**SANDLEFORD PARK 20/01238/OUTMAJ**  
**RESPONSE TO COMMENTS FOR CONSULTEES**

September 2020

Project: Sandleford Park

Client: Bloor Homes Limited and Sandleford Farm Partnership

DRAWING TITLE:  
**Eastern Site Access**

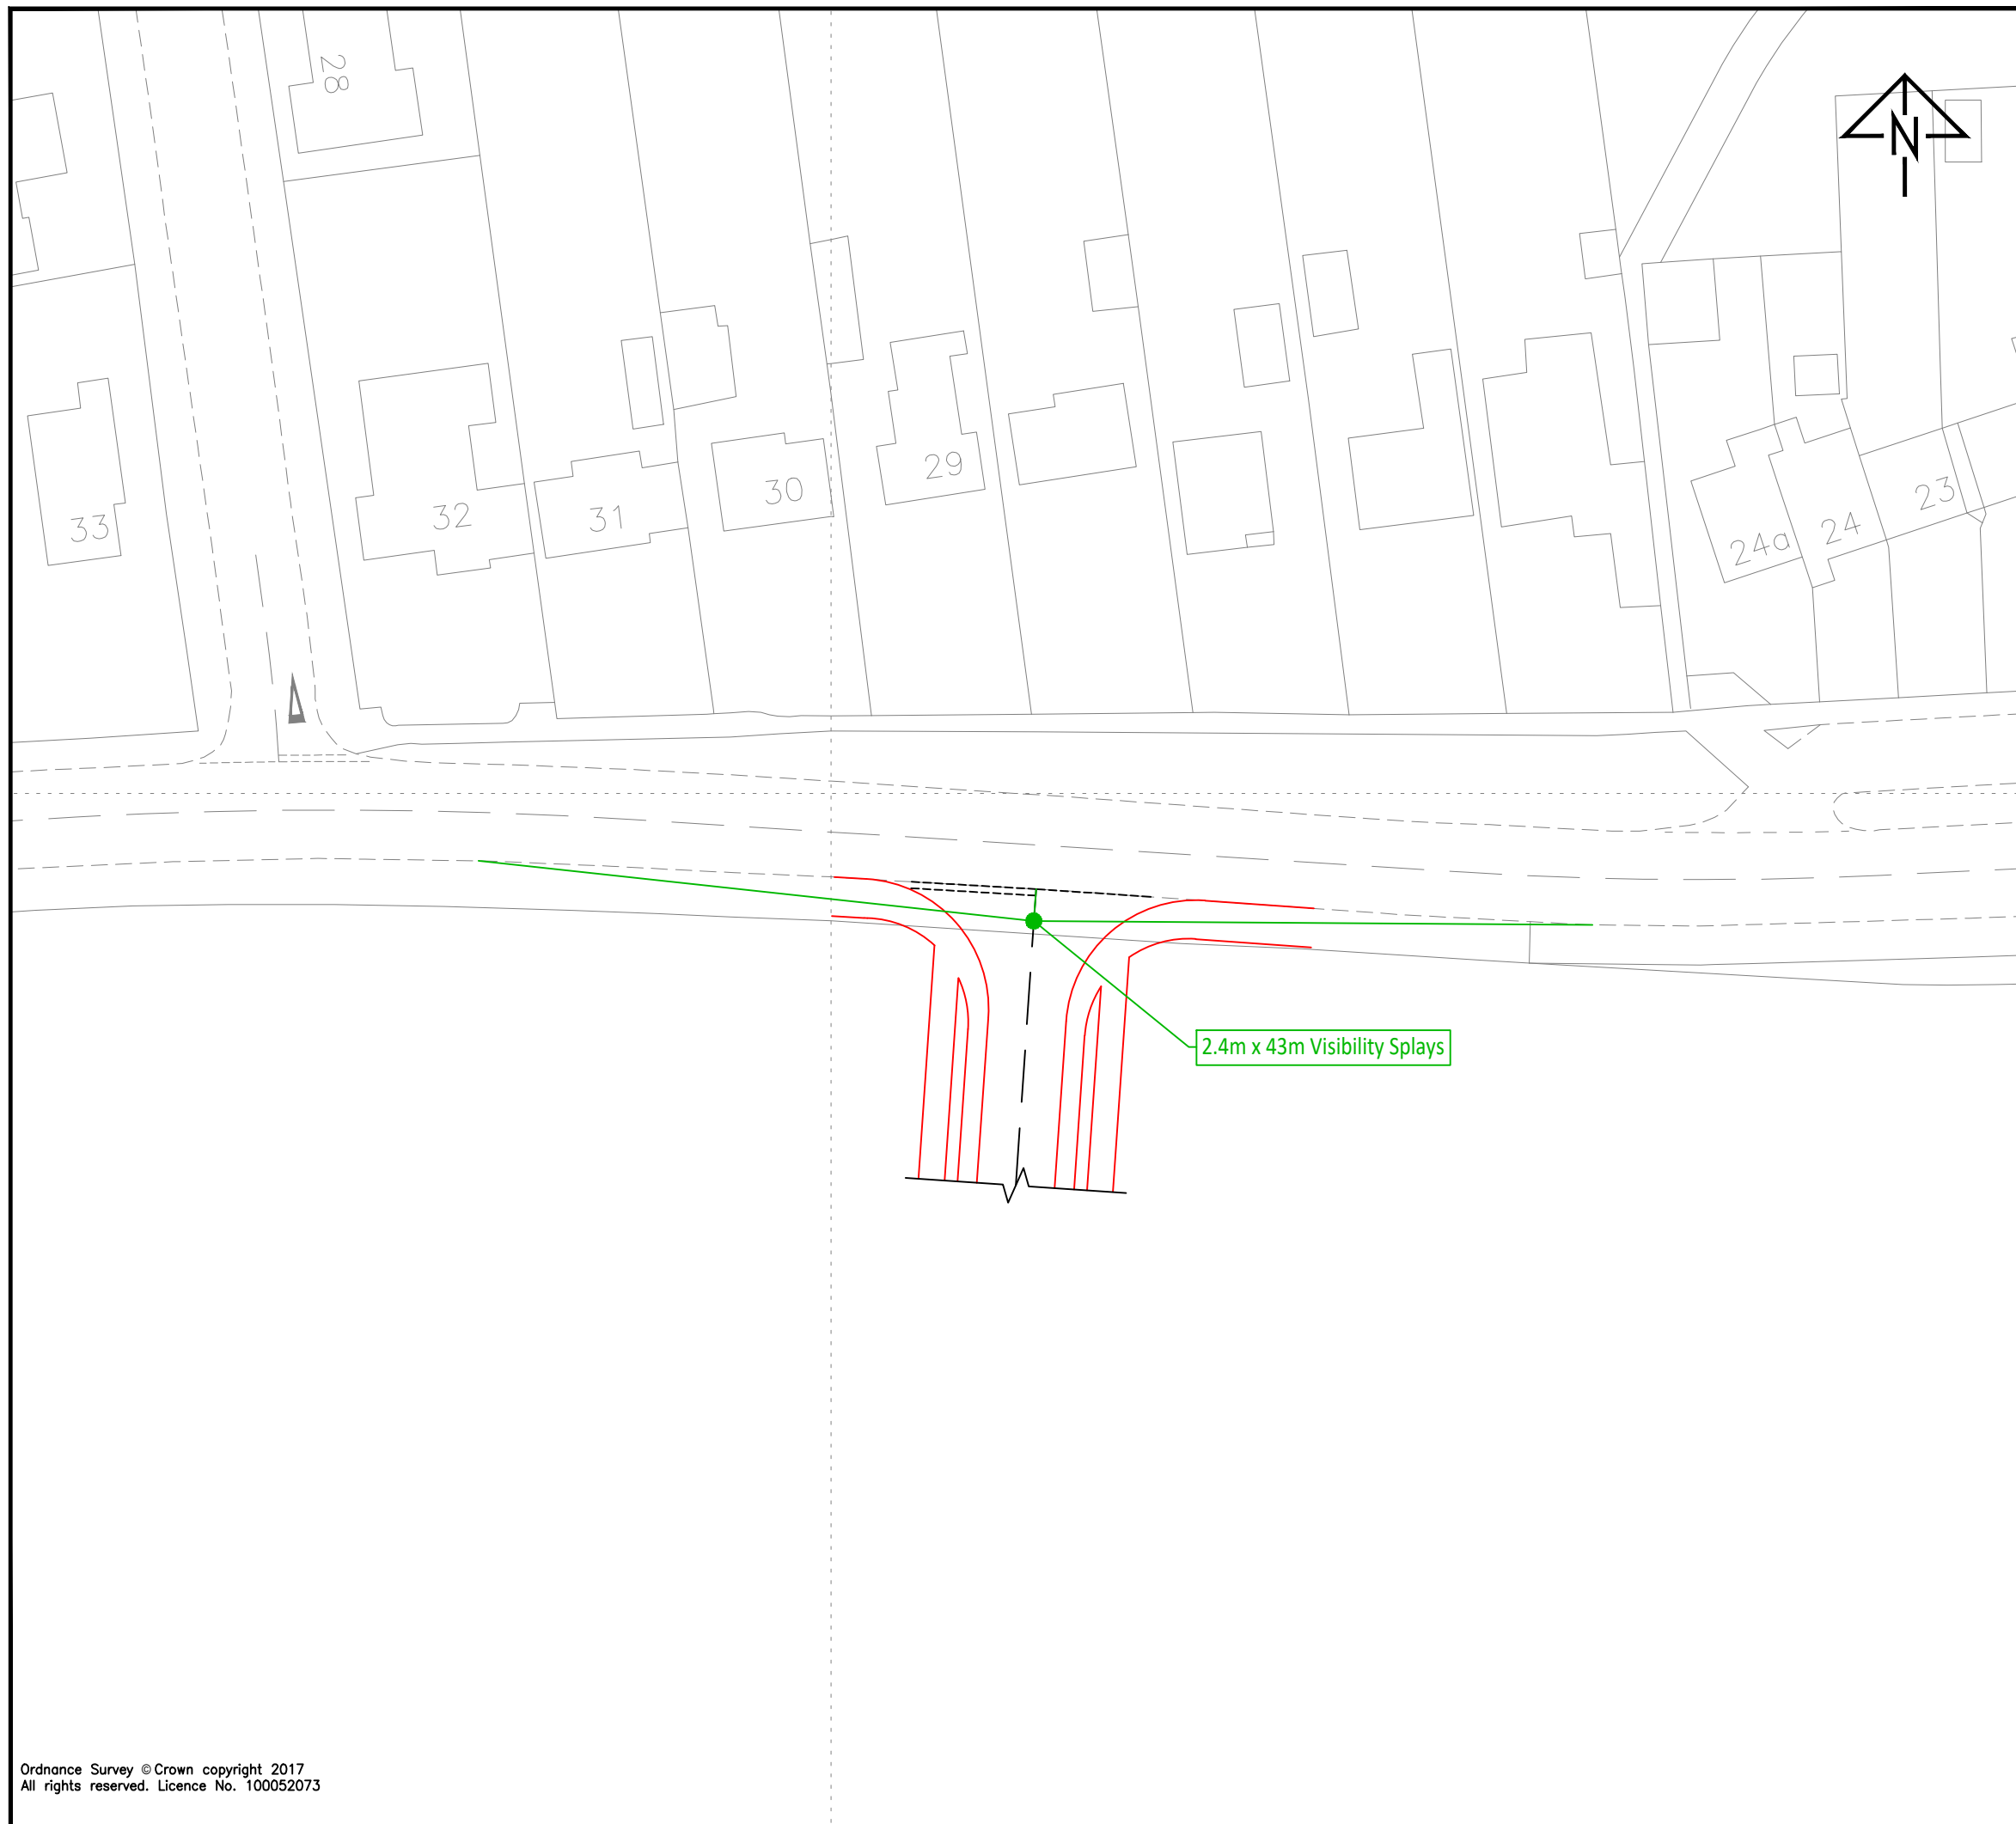
- 2.8 **Public Right of Way.** A 3m wide emergency access is proposed to run adjacent to the Public Right of Way Footpath Greenham 9, which would connect the site to the A339. It has been stated that the emergency route would need to be a 3.75 metre bonded surface. A detailed design for this route, including its alignment and surface treatment, could be conditioned by the LPA or included with the Country Park Scheme which is to be designed in detail at a later stage. This detailed design would take account of the proximity of the existing Public Right of Way to Waterleaze Copse.
- 2.9 **Visibility Splays.** 2.4x43 metre visibility splays have been added to the two access drawings and these are included at *Appendix 1*.

REV.	A	Visibility splays added	CJM	TF	23.09.2020
		DETAILS	DRAWN	CHECKED	DATE
